Lucy V. Barnsley Elementary School Addition, Mandatory Referral MR2016027

Staff Report Date: 6/13/16

- Staff recommends Approval to transmit comments to the Montgomery County Public Schools (MCPS). There are no major issues with the proposed mandatory referral.

Figure 5: Proposed Site Plan

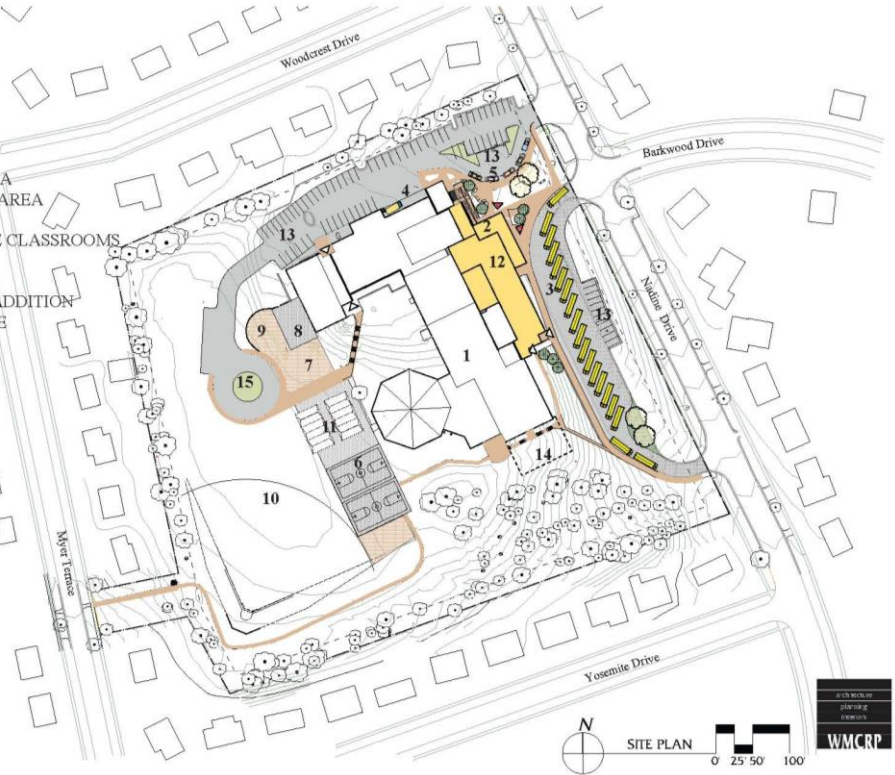
2. Upgrade the existing substandard four-foot wide sidewalk along Nadine Drive between Woodcrest Drive and Yosemite Drive to the current County standard of 5-foot-wide sidewalk with adequate green panel.

3. Provide at least three inverted-U bike racks (six bike spaces) and 14 bike lockers near the two school entrances in a weather-protected area.
4. Relocate the two regular and two ADA accessible parking spaces in the school's parking area from inside the drop-off/pick-up loop island to outside the loop and closer to the sidewalk and main entrance, and eliminate the marked pedestrian crosswalk associated with these parking spaces.

5. Restripe the existing faded crosswalk markings on Nadine Drive.
6. Add new planting to the existing buffer between the parking and turnaround circle in the rear of the site and the residences along Myer Terrace and Woodcrest Drive by complying with the Zoning Ordinance's Section 6.2.9 perimeter planting requirement for parking facilities.

The Proposal shows no additional landscaping to buffer the school's rear yard where new parking spaces and a turnaround is planned. This additional pavement and vehicular activity in the rear of the site will be closer to the rear yards of the residences along Myer Terrace and Woodcrest Drive. Staff believes that additional landscaping should be provided to buffer the increased vehicular activities. At a minimum, MCPS should add landscaping along the school's rear property line to comply with the Zoning Ordinance's minimum requirement of a ten-foot wide strip of planting with a hedge, fence, or wall; canopy tree every 30 feet on center; and at least two understory trees for every canopy tree (Section 6.2.9).
